Appearance Review Board Staff Report

ARB2020-10022

504-522 West Central Boulevard Orlando Magic Training Facility

ARB Staff Courtesy Review Comments

City Staff Recommended Site Plan

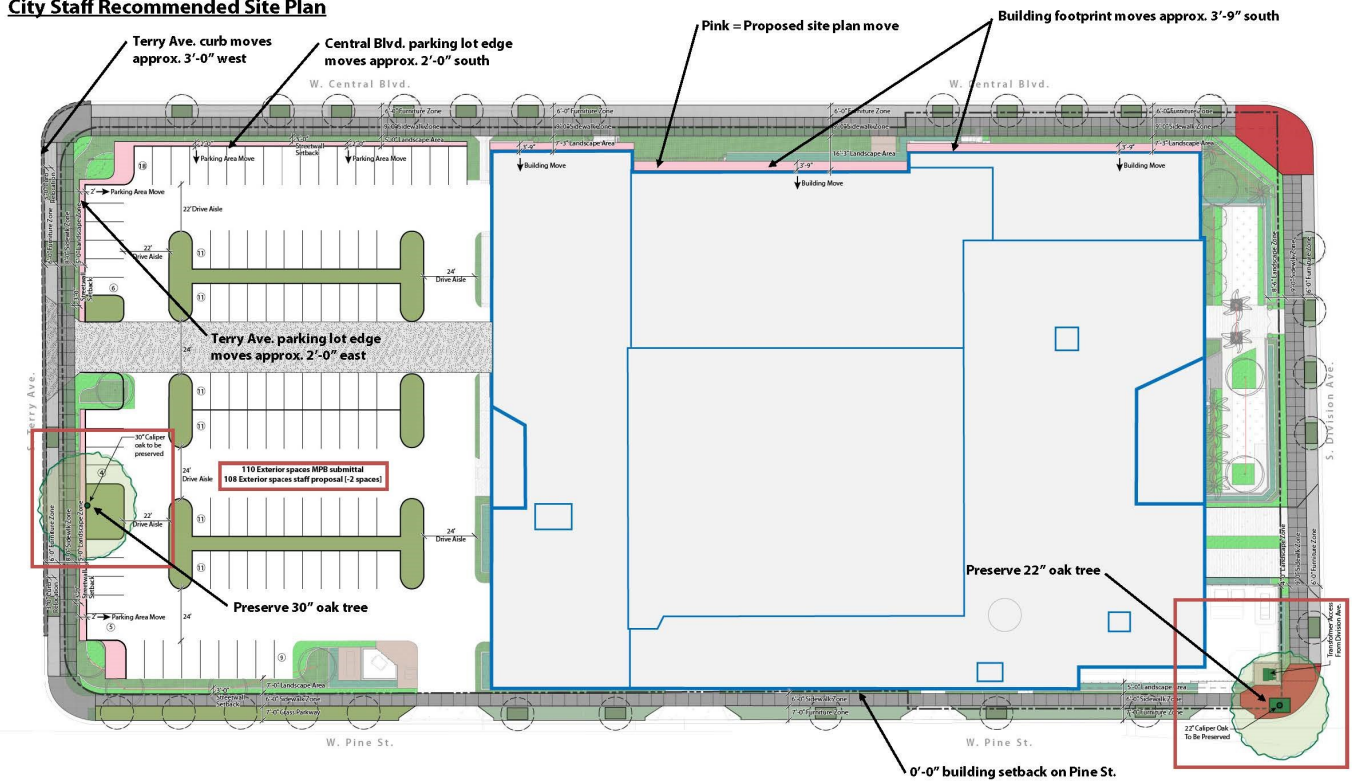
Staff has recommended alternatives to the proposed site plan in an effort to better meet the Downtown Orlando Streetscape Guidelines and provide a better pedestrian experience along Division, Terry and Central and the summary and graphics follow:

1. Move the entire building footprint approximately 3'-9" to the south. This will create a zero-foot building setback on Pine St., but will not require any changes to the actual building footprint. The 3'-9" move will provide enough room for the required 15-foot streetscape zone and code compliant 7'-0" minimum landscape buffer along the Central Blvd. parking garage frontage.

2. Move the north edge of the surface parking along Central Blvd. 2-feet to the south, reducing the northern drive aisle width from 24-feet to a still acceptable 22-foot wide drive aisle. This move will accommodate the required 15-foot streetscape zone and a 5-foot landscape buffer with a streetwall.

3. Move the Terry Ave. curb 3-feet to the west, eliminating the tamper in between Pine St. and Central along Terry, and move the western edge of the parking area along Terry 2-feet to the east. This alteration will allow for a 14-foot wide streetscape and 5-foot landscape buffer with streetwall along the Terry Ave. parking lot frontage.

Staff Recommended Surface Lot Plan

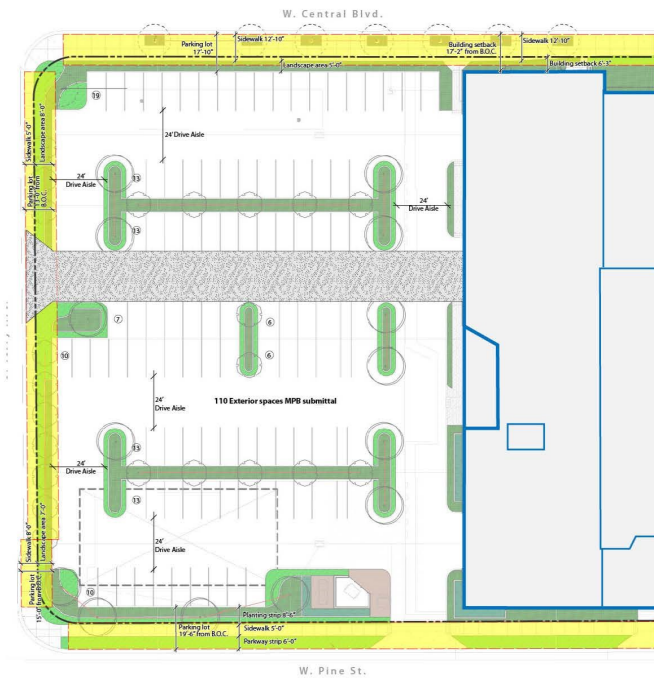
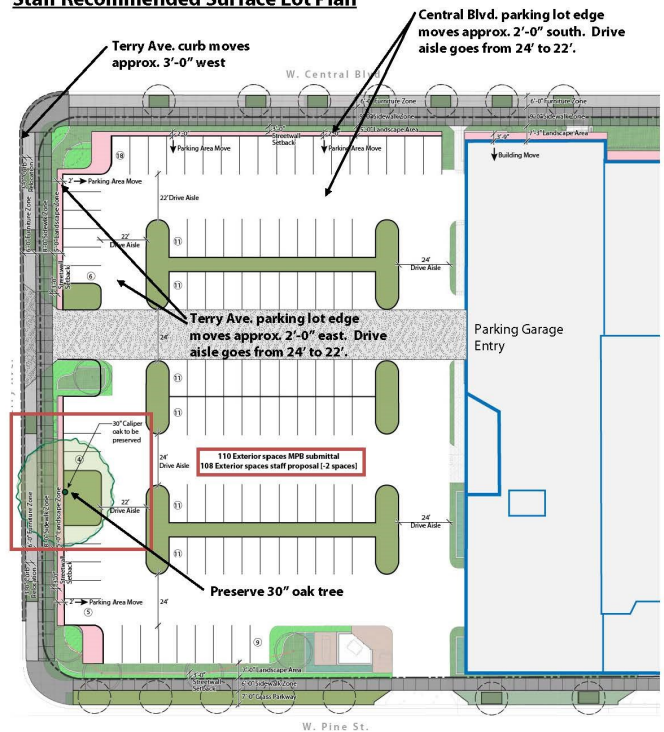
5. Based on the above parking area modifications staff has redesigned the surface parking configuration to allow for sufficient area to preserve the existing 30-inch caliper oak tree along the Terry Ave. frontage while only reducing the parking yield by 2 spaces, from 110 surface parking spaces to 108 surface parking spaces.

Division Ave. Streetscape Staff Recommendation

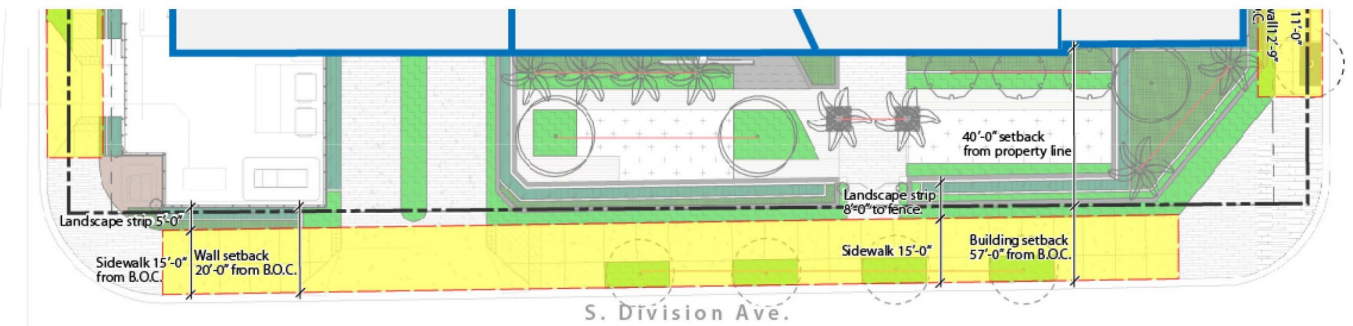
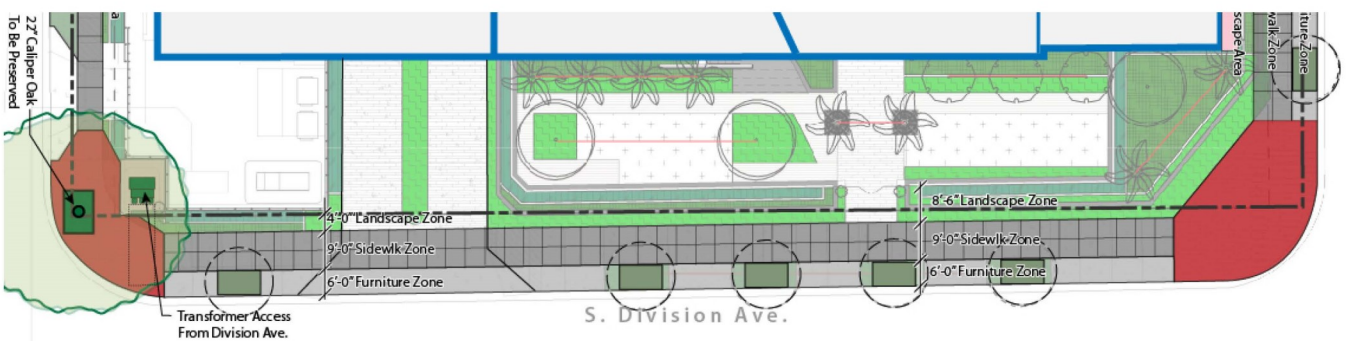
- iii. N. Division Ave.—The streetscape along Division Ave. must match the existing Division Ave. streetscape [3.7.1 in the streetscape design guidelines] including window-pane concrete sidewalks scored on a grid pattern, double-acorn streetlights, street trees, custom steel guards around rectangular tree wells, planter pots, and street names etched onto crosswalk pavers. High-rise live oaks should be utilized for street trees.

6. Preserve the existing 22" caliper oak tree at the corner of Division and Pine. The tree location doesn't interfere with the building footprint and a 6-foot wide sidewalk can be provided between the tree and the proposed transformer if the transformer at the corner of Division and Pine is rotated 90 degrees so it fronts and is accessed off of Division.

Central Blvd. Building Frontage Staff Recommendation

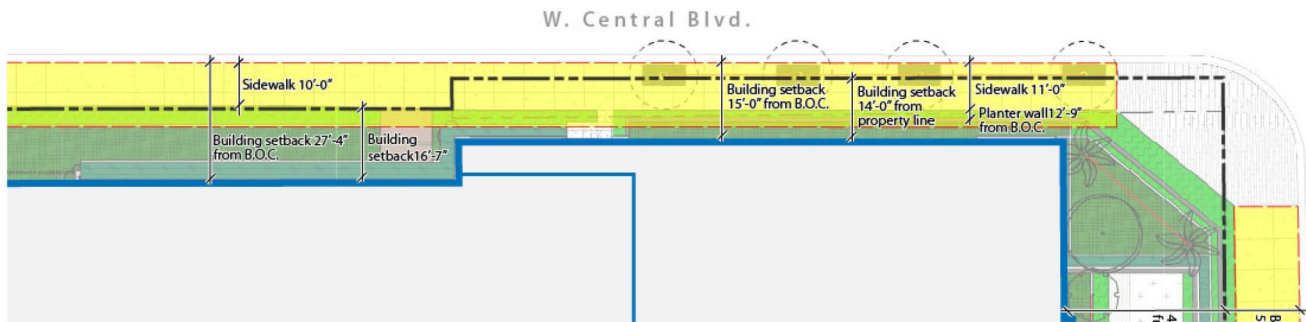
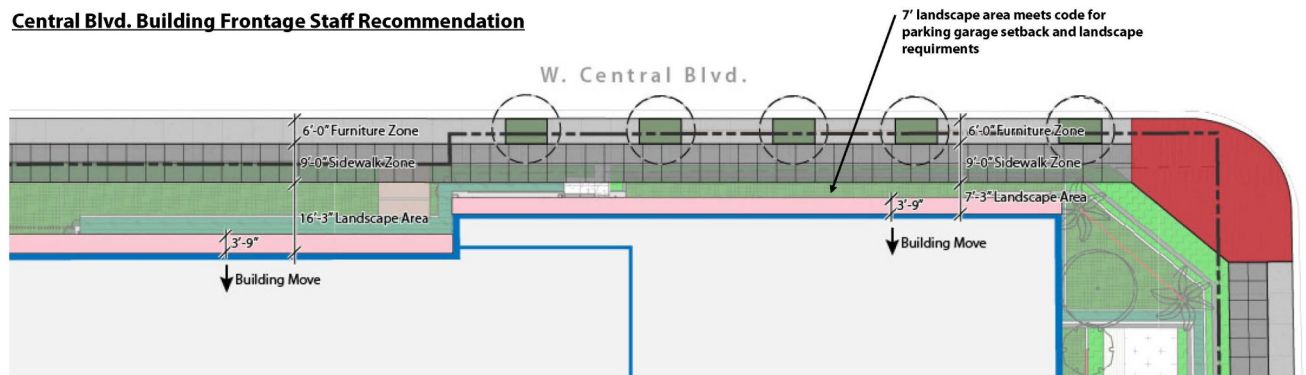
- i. W. Central Blvd.—The minimum streetscape width on West Central Boulevard must be a minimum of 15-feet from back-of-curb. The furniture zone must be concrete and a minimum of 6-feet wide along the entire project frontage. The pedestrian clear zone must be concrete and a minimum of 9-feet in width. The sidewalk must be scored on a 4.5-foot by 4.5-foot grid. Tree wells should be 6-feet by 9-feet. High-rise live oaks should be utilized for street trees.

Pine St. Parking Lot Frontage Staff Recommendation

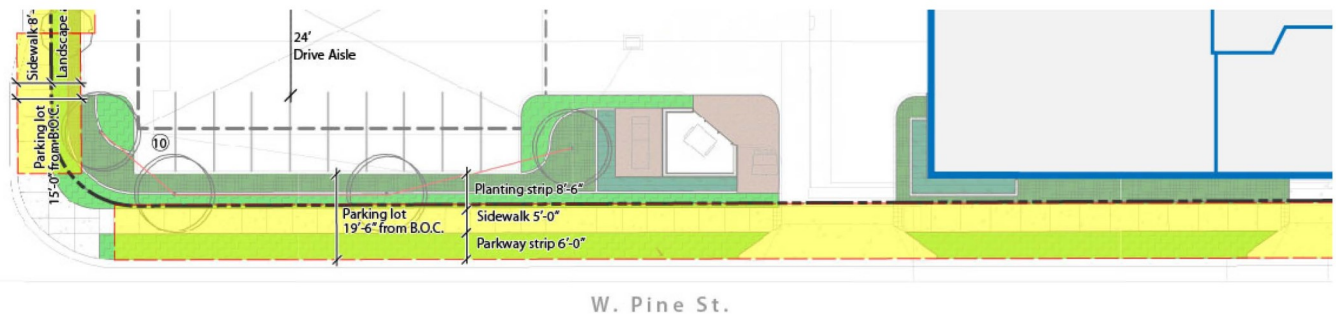
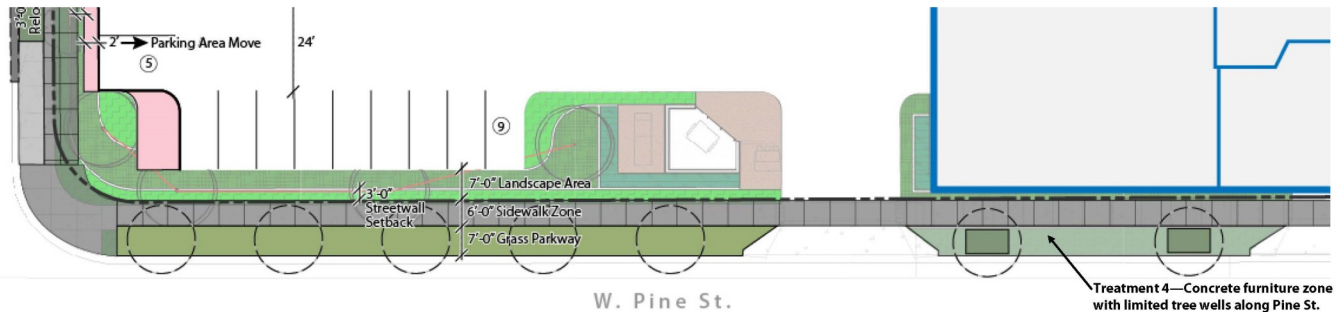
4. Along the Pine St. parking lot frontage provide a 7-foot grass parkway strip with canopy trees and a 6-foot wide sidewalk. Along the Pine St. building frontage provide a 13-foot wide concrete streetscape zone [Treatment 4] with minimal tree plantings. The Treatment 4 streetscape will accommodate the Magic's desire to park media and broadcast vehicles along the Pine St. building frontage.

Pine St. Building Frontage Staff Recommendation

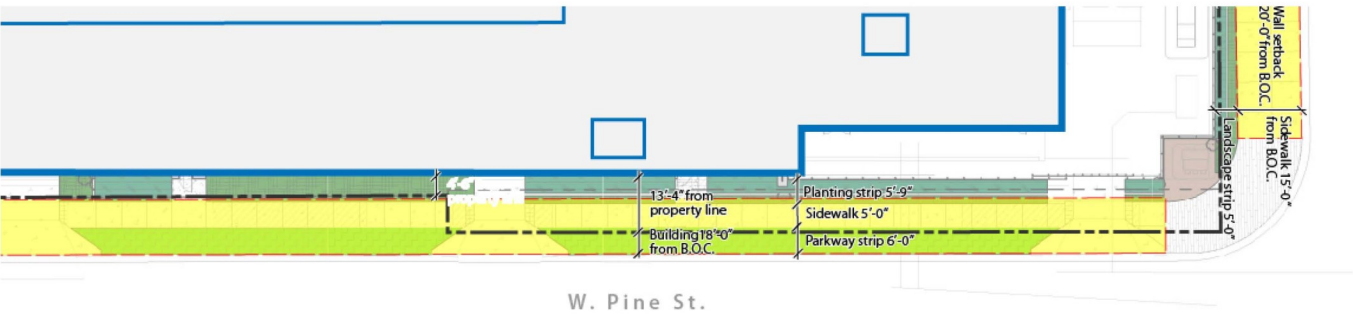
- ii. W. Pine St. —The streetscape treatment on W Pine St. must match Treatment 4 of the Downtown Streetscape Design Guidelines behind the building frontage or an alternative as shown in staff recommendations. The 7-foot furniture zone and 6-foot wide pedestrian clear zone must be paved with 5-foot by 5-foot concrete cells. The sidewalk cells must have a 2-inch troweled edge with a medium broom finish, The broom finish must be perpendicular to the centerline of the street. Along the W. Pine St. parking lot frontage the streetscape zone will transition to a 7-foot wide grass parkway strip with canopy trees and a 6-foot wide sidewalk. Tree wells should be 7-feet by 9-feet. High-rise live oaks should be utilized for street trees.
